CITY OF RAYMORE

ADDENDUM NO. 1

T.B. Hanna Station - Site Work
Project #19-276-203

Addendum No. 1 - Question and clarification.

UTILITY PLAN

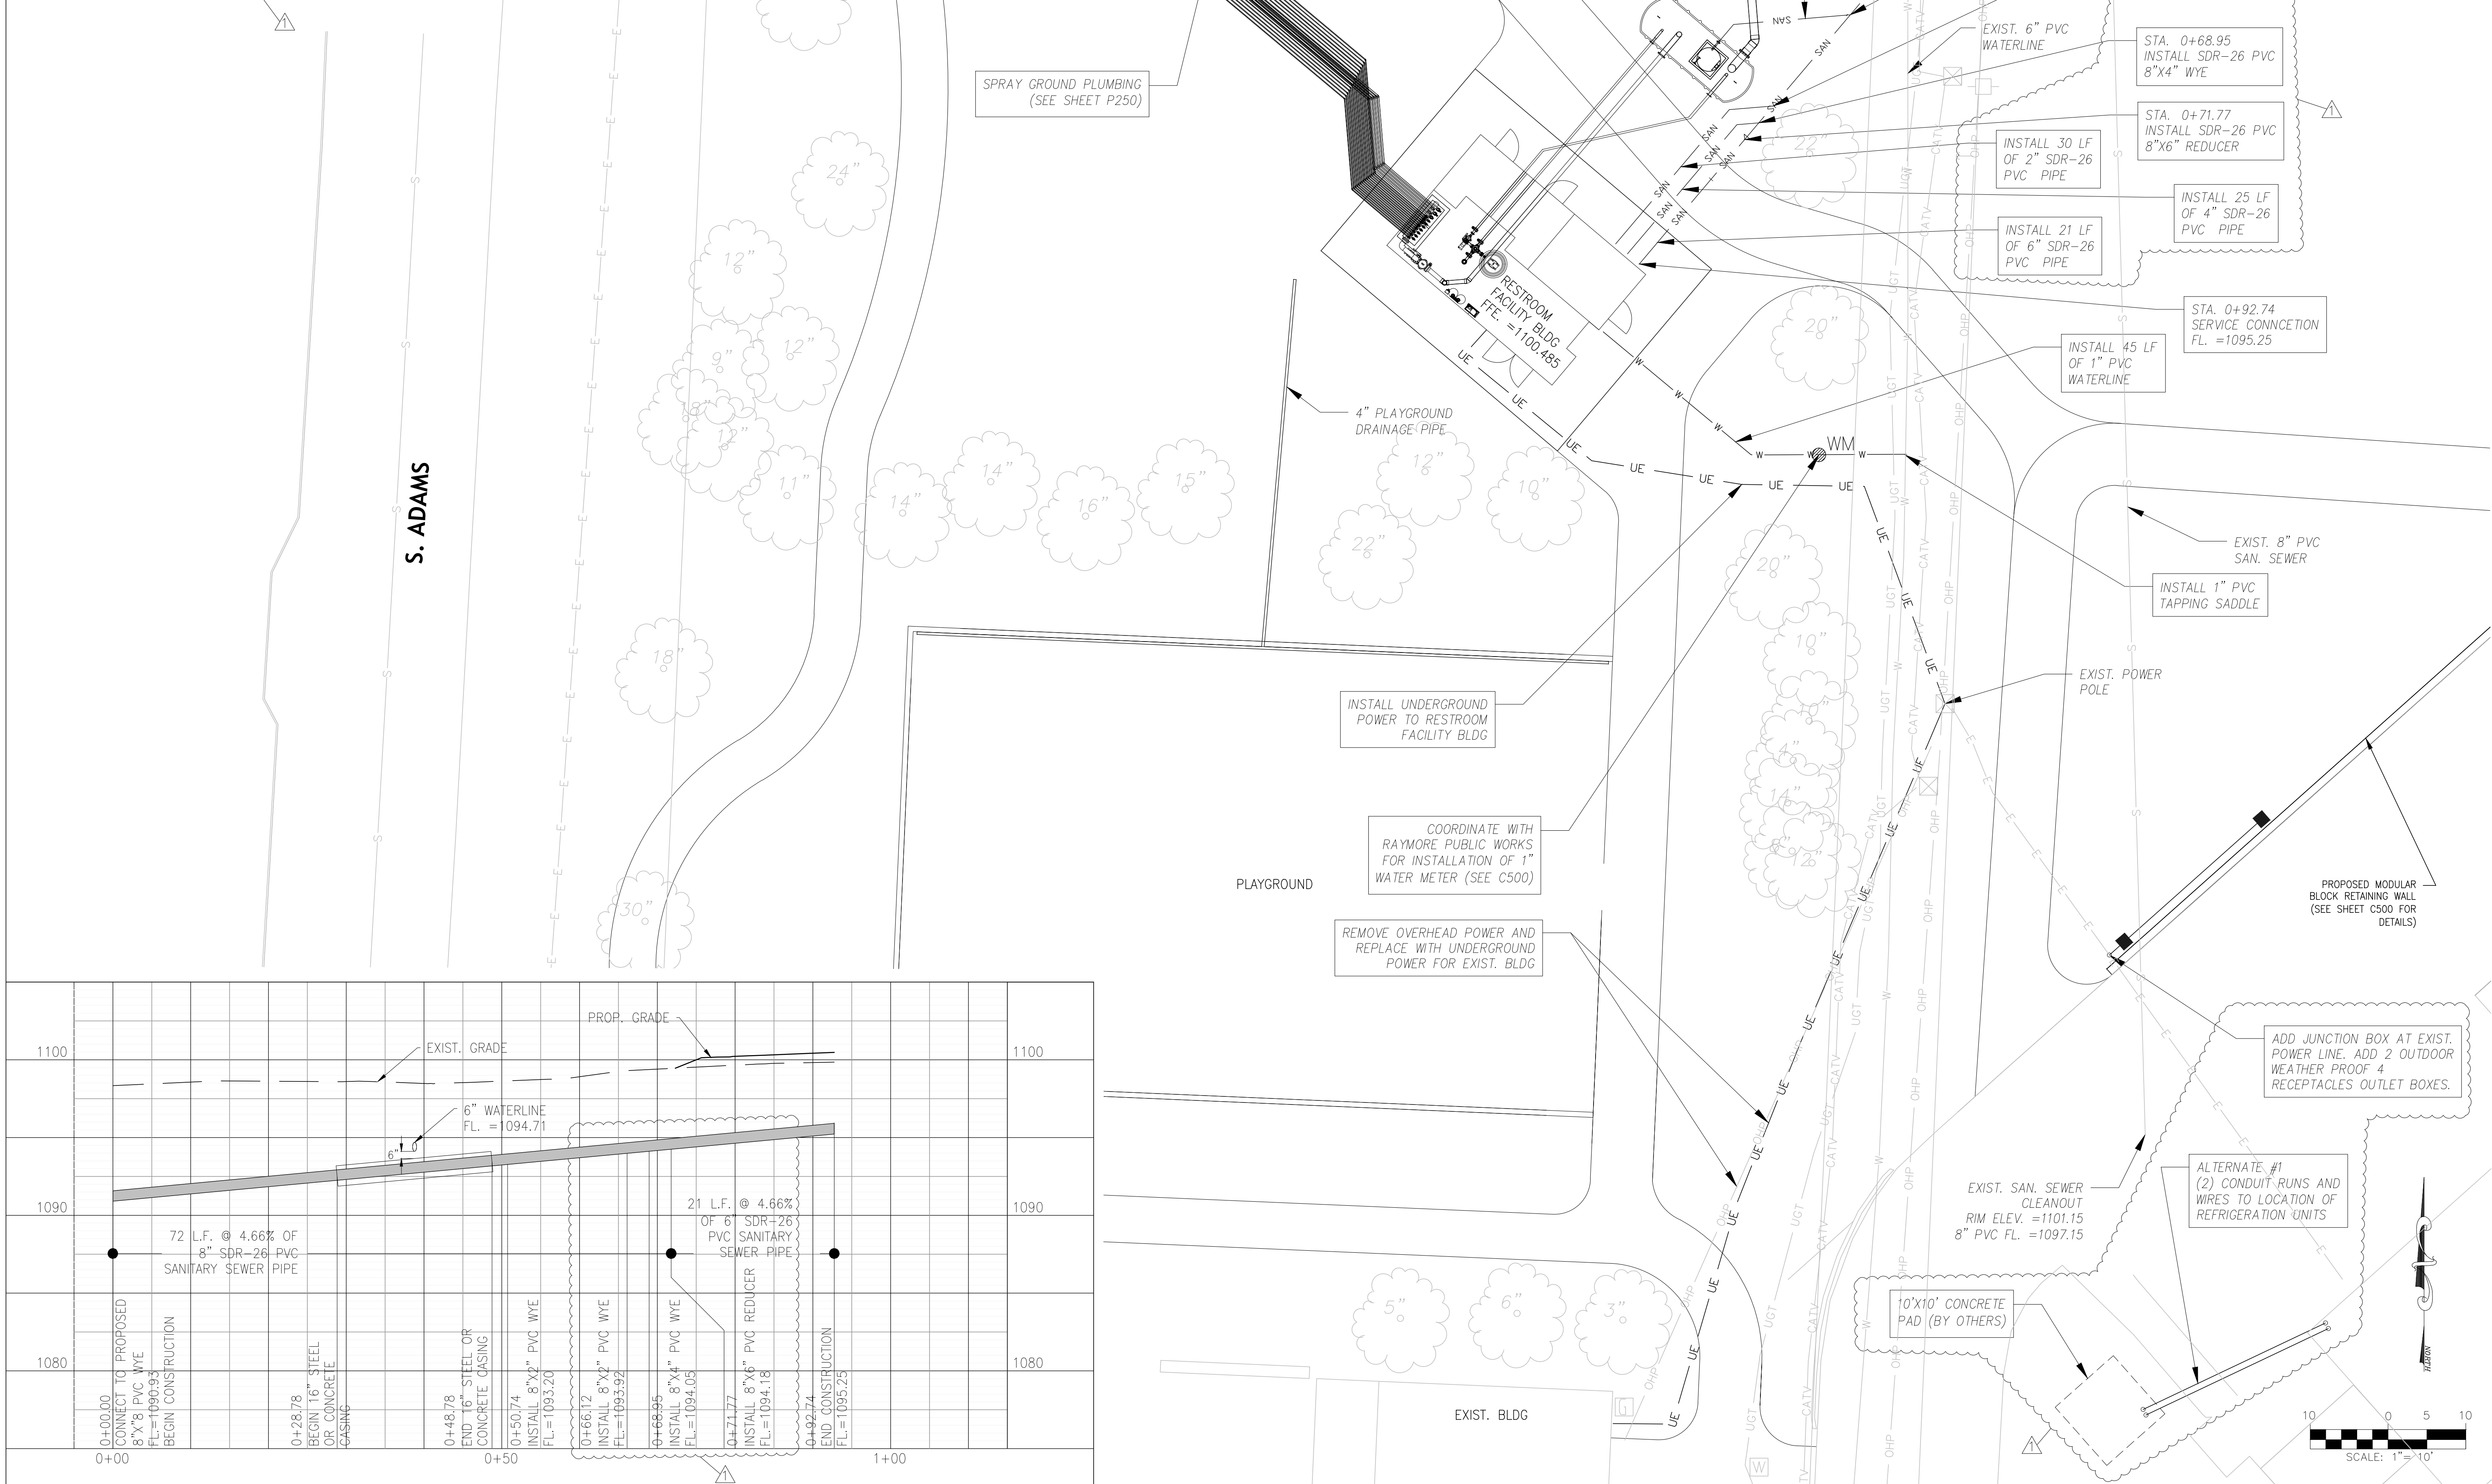
2. Clarification: The Sanitary Sewer lines for the prefab bathroom will stop at 6' from the building line. See attached Sheet C300.

- CONTRACTOR TO ACQUIRE CONSTRUCTION AND ELECTRICAL PERMIT FROM CITY. THERE IS NO FEES FOR CITY PROJECT PERMITS.
- ALTERNATE #1 - CONTRACTOR TO PROVIDE ELECTRICAL POWER CONNECTION FOR 200 AMP ELECTRICAL PANEL ON NORTHWEST CORNER SHELTER SUPPORT UNDER CONCRETE PAVEMENT TO LOCATION OF NEW REFRIGERATION UNITS. CONTRACTOR TO CONNECT POWER TO REFRIGERATION UNITS WITH FLEXIBLE CONDUIT AFTER INSTALLATION.
